Glitch & Fix April 2018

Knock On Wood

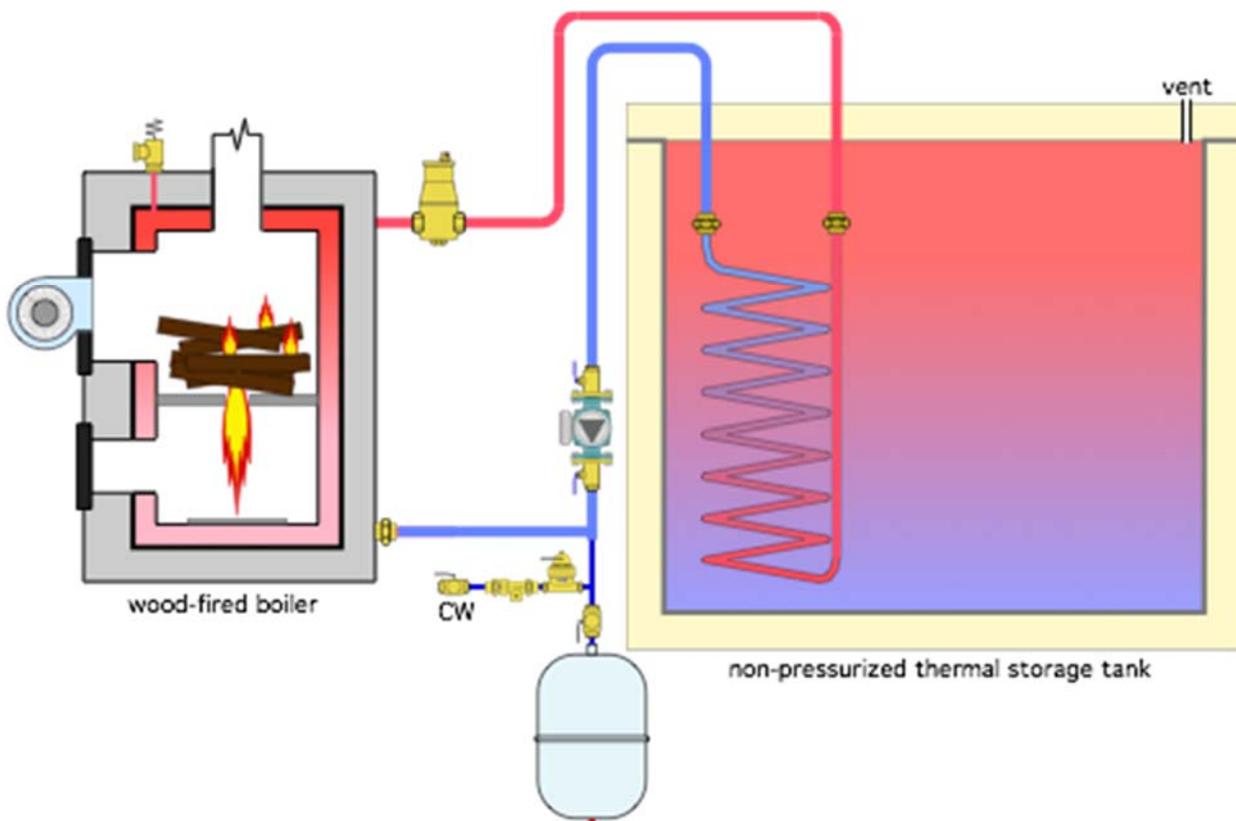
A cordwood gasification boiler gets piped as shown. The boiler has a steel fire tube heat exchanger. The tank is non-pressurized and has a vent hole through the upper lid. The heat extraction portion of the system is not shown. Can you identify at least 5 errors with this configuration.

1. All cordwood gasification boilers require a heat dump that can safely dissipate residual heat from the fire if a power outage occurs. A passive heat dump is common. It consists of an array of finned-tube installed above the boiler, supplied through a normally open zone valve. The latter opens when power is lost to allow thermosiphon flow between the boiler and finned-tube array.

2. All cordwood gasification boilers are designed to operate without sustained flue gas condensation. Some means of monitoring boiler inlet temperature, and reacting to keep that temperature above a minimum of about 140 °F must be provided. In the fix drawing this is handled by a “loading unit”, which combines a thermostatic mixing valve with a circulator.

3. For best performance, all heat exchangers should be piped so that flow passes through or across them in opposite directions. This is called counterflow. As water in the tank is heated buoyancy forces cause it to rise as shown by the white arc in over the heat exchanger coil. Thus, for counterflow, the hottest water from the boiler should enter the top of the helical portion of the coil.

4. There should always be an air space between the water level in the tank and the underside of the cover. That space is intended to accommodate the increase in volume as the water is heated. As shown, the tank is completely filled with water. When the water is heated it will rise and likely leak out through the vent opening at the top.

5. In the original design the circulator is pumping toward the point where then expansion tank connects to the circuit. Circulators should always pump away from that point.

6. There is no check valve in the circuit to prevent reverse thermosiphon flow when the tank is hot and the boiler cools off. If allowed to occur, reverse thermosiphon flow will dissipate heat from the tank through the boiler and adjacent piping.

7. There is no union on the upper piping connection to the boiler, but there is on the inlet connection. Unions aren't required, but it makes no sense to install one and not the other.

8. Although it may be possible to pass the piping leading to the heat exchanger through the top of the tank, this could complicate lid removal is necessary. It's been to pass piping through the upper sidewall of the tank above the maximum water level.

These details have been resolved in the fix drawing below.
